STAFF REPORT

December 3, 2019

- RE:**
- 8.1 CD-CPC-2019-00024- Area Plan Amendment**
 - 8.2 CD-CPC-2019-00023- Rezoning for Staley Corners West**
 - 8.3 CD-CPC-2019-00022- Development Plan for Staley Corners West**
 - 8.4 CD-CPC-2019-00025- Rezoning for Staley Corners East**
 - 8.5 CD-CPC-2019-00026- Development Plan for Staley Corners East**

REQUEST: To approve an area plan amendment, two rezoning requests, and two development plans which will each serve as preliminary plats to allow for a commercial and residential development.

Figure 1. Proposed Zoning (R-1.5 in pink, B2-2 in peach, B4-3 in green)

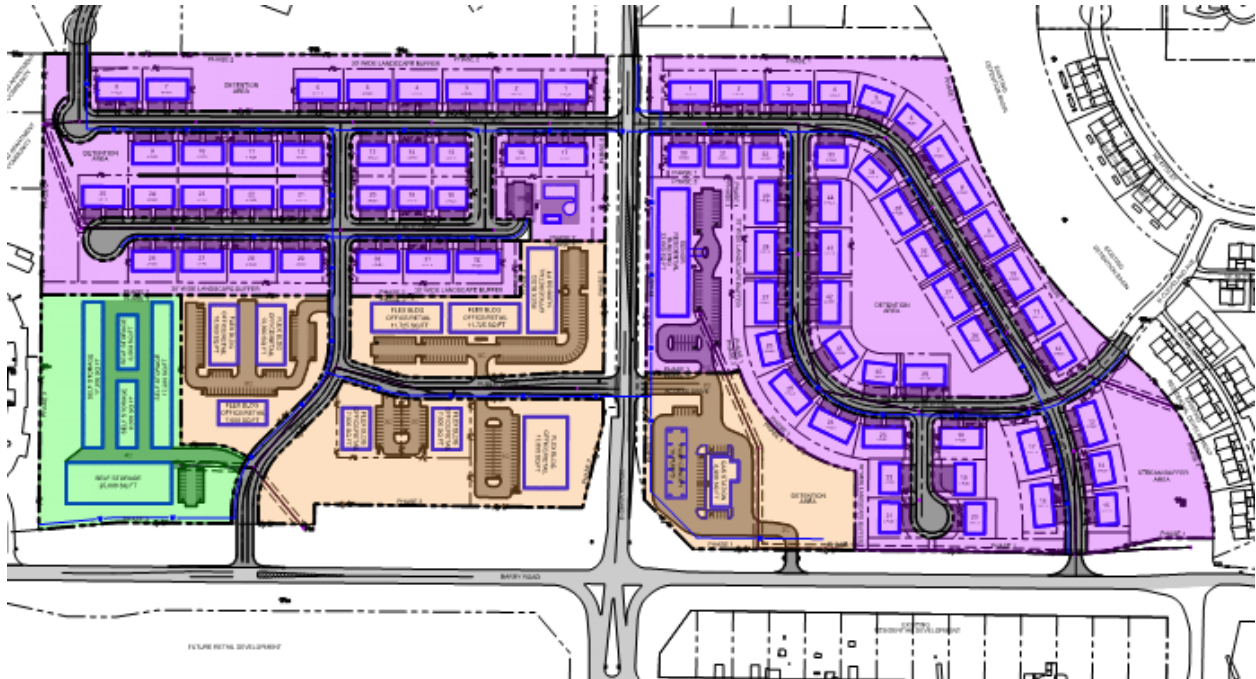
The effect of the proposed rezonings is to shift commercial from Staley Corners East to Staley Corners west as East will be downzoned (except for the small area near the intersection) and West will be upzoned. This pattern of zoning is consistent with the existing pattern of zoning and development to the south where Marketplace 152 is located west of Indiana (directly south of Staley Corners West) and residential is located east of Indiana (directly south of Staley Corners East). For this reason staff does not believe an area plan amendment is necessary; however, the proposed B4 zoning at the southwest corner of Staley Corners West does trigger the need for the proposed amendment as it is more intense than current zoning.

Figure 2. Staley Corners East

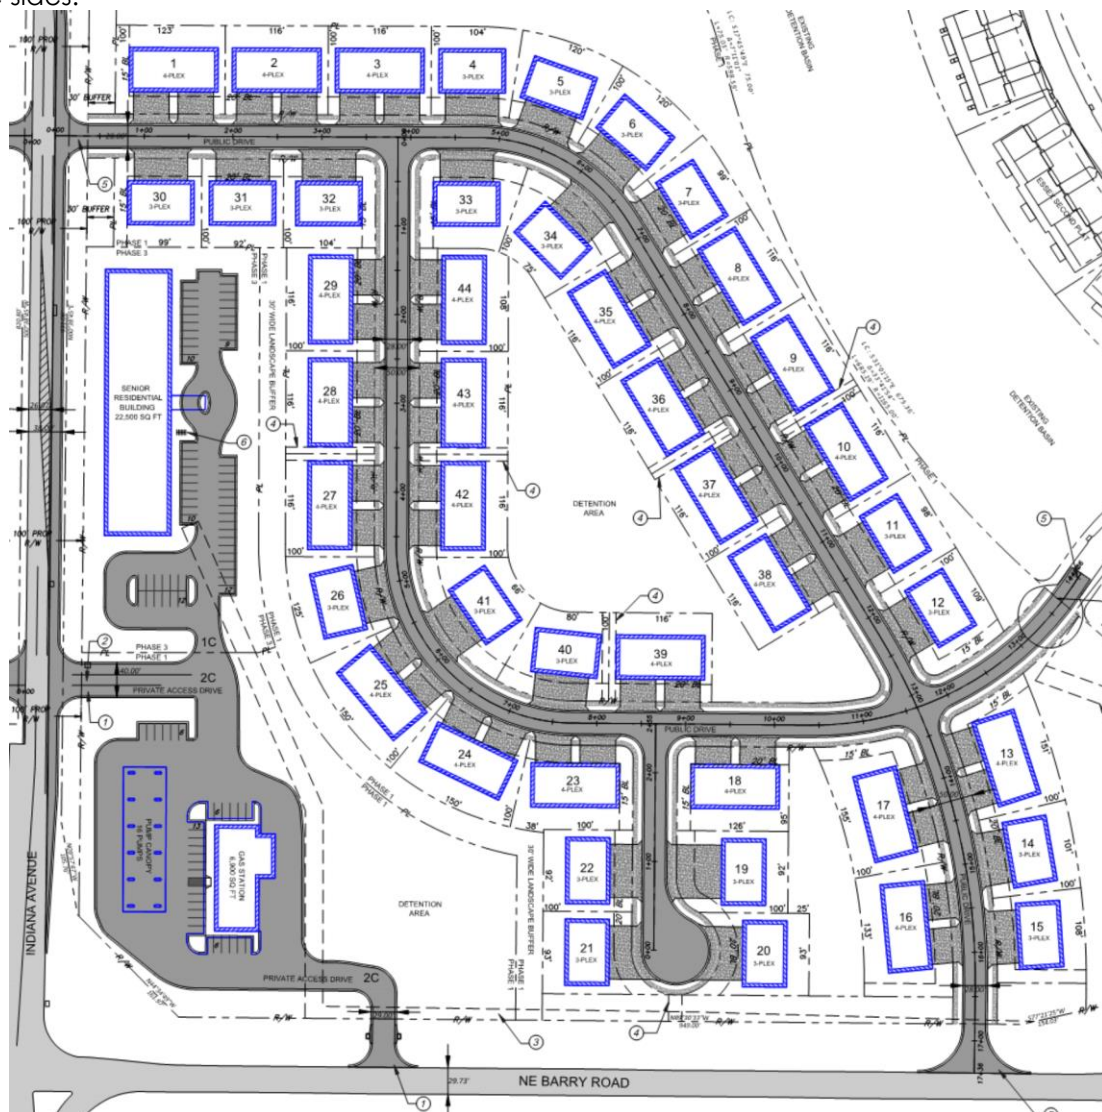
This area will consist of a gasoline and fuel sales use with convenience store, senior residential apartments and 196 units in 44 residential buildings some of which will contain three units each with the remainder containing four units each. Staff's understanding is that the applicant will be the developer for the residential component and will sell the remainder with the lot for the proposed gas station being the first likely development. These buildings must follow the attached

house standards of the zoning and development code. The intent of the standards is to improve upon the aesthetic characteristics of developments containing attached houses (commonly referred to as duplexes, triplexes or townhouses) by limiting the width and placement of driveways and garages and ensuring the buildings themselves are architecturally distinct. For example, garages cannot occupy more than 40% of the front façade of each building, and each unit must have an entrance oriented toward the street. It is not clear whether the current proposal complies, so staff is recommending conditions related to this.

As mentioned previously, staff is generally supportive of the upzoning of Staley Corners West because this area will be downzoned except for the gas station site. Staff finds this an improvement over the existing situation as this site is surrounded by residential on three sides whereas Staley Corners West is surrounded by residential on two sides. The gas station itself will be buffered from adjacent residential developments by the proposed residential on two of the three sides.

- b. Add a note to the plans stating how parkland dedication will be satisfied.
 - c. Show a pedestrian connection in Staley Corners East between from the street and going between residential buildings 25/26 and connecting to the private drive providing access to the gas station and senior housing.

- d. That the driveway widths be narrowed or combined so as to provide sufficient space between each driveway for a street tree and to improve the pedestrian experience.
